Electrical installation condition - 8 October 2026

Project	Riverside Court - Cat B Fit-Out, Phase 2
Client	Halloway Cross Estates Ltd
Address	Riverside Court, 42 Kelham Street, Sheffield S3 8LP
Reference	EIC-2026-10-001
Report date	8 October 2026
Status	Published as version 1 on 8 October 2026
Items included	10

Item 1

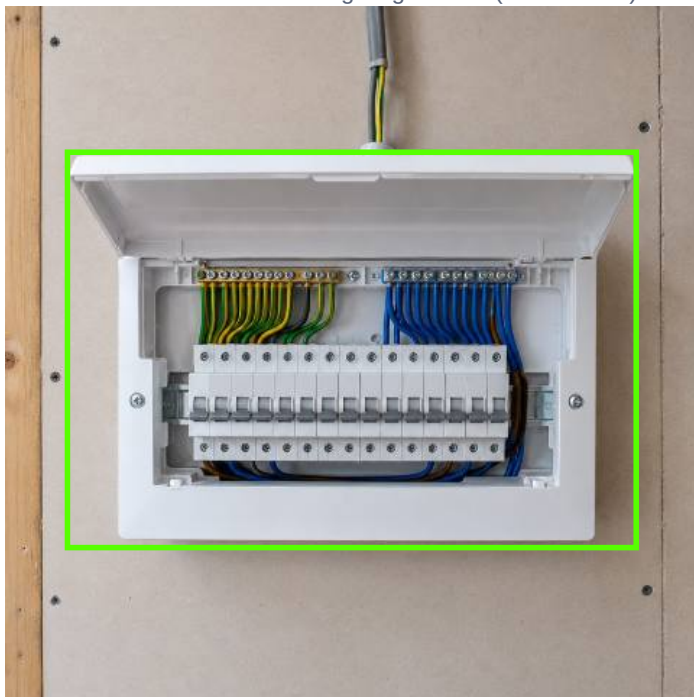
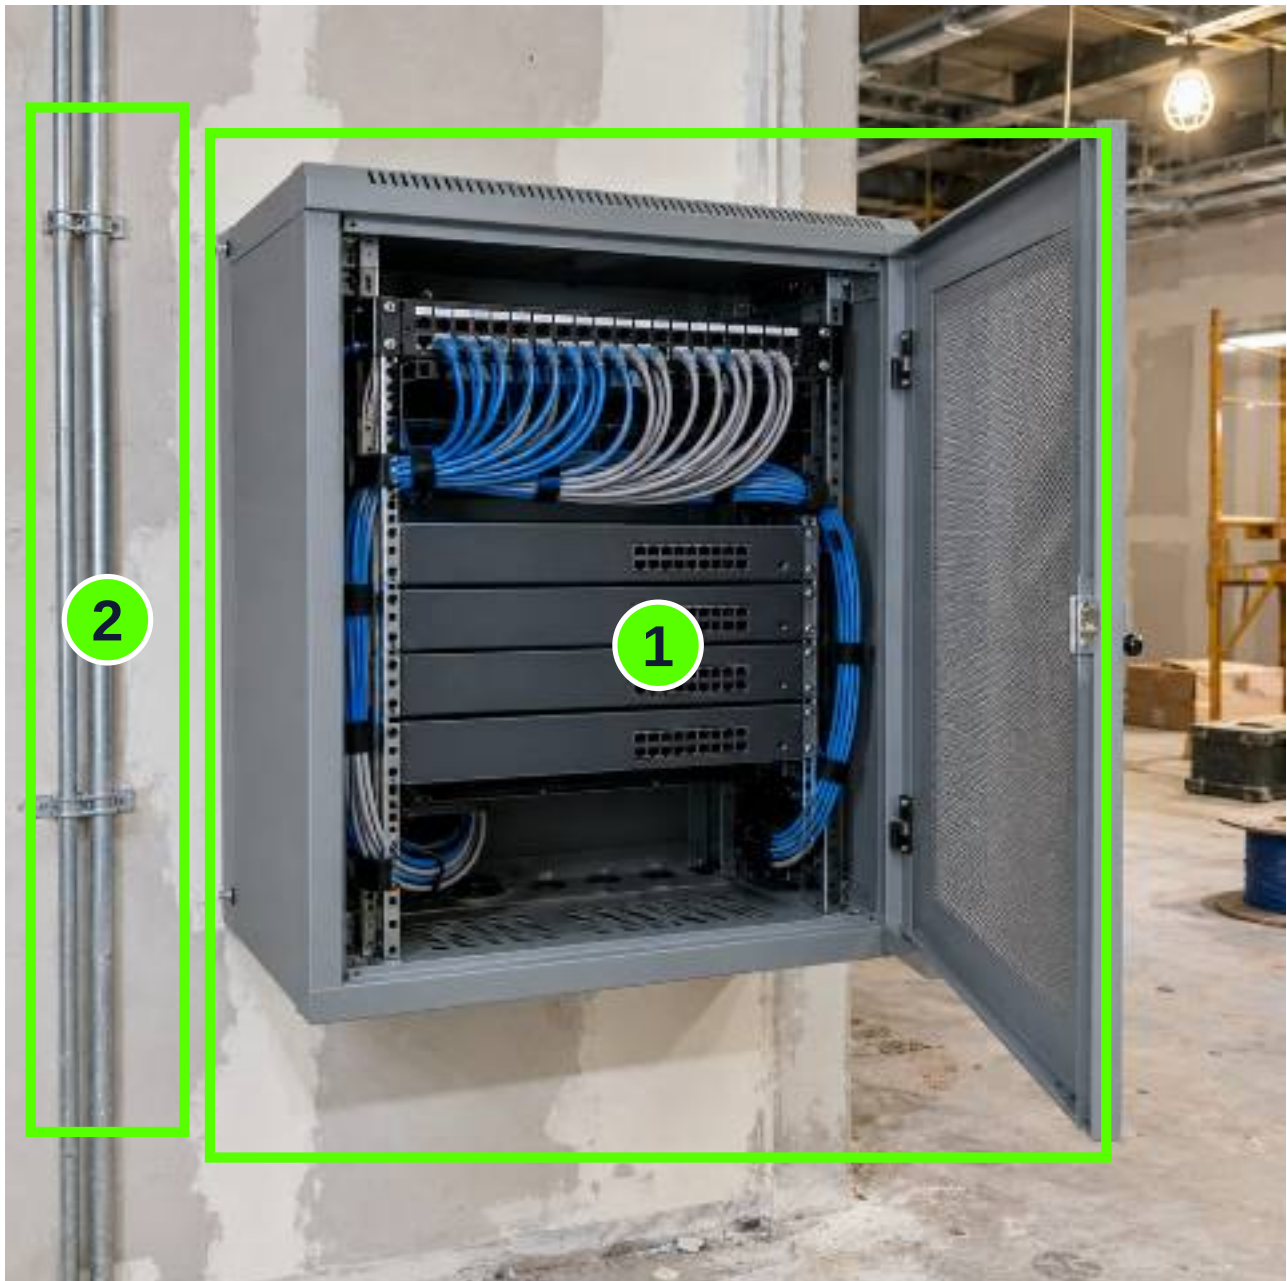
A consumer unit is mounted on a plasterboard wall with the front cover removed, exposing the busbar, neutral bar, earth bar and the incoming meter tails above the enclosure. The internal connections are visible but the cover is not fitted and the installation cannot be judged complete from this view.

Do not energise or leave energised with the cover removed. Confirm isolation and lock-off, then have a competent person refit the front cover and verify the enclosure is complete and secure before the installation is put back into service.

Pin 2 of 2 - photograph 2

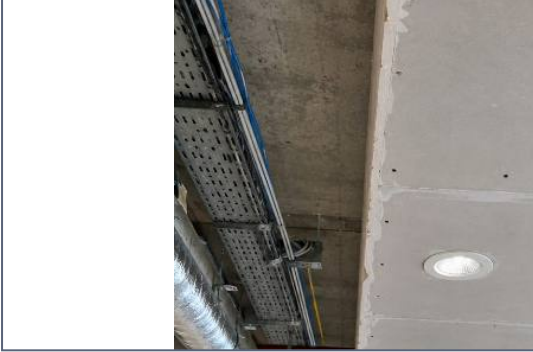
To the left of the image, cable tray and basket containment are installed at high level above the ceiling line, carrying services in a runs arrangement with drops to plant. The containment is supported at regular intervals and the cable runs within it are laid in an orderly manner. No defect in the containment or its support is apparent at the distance shown.
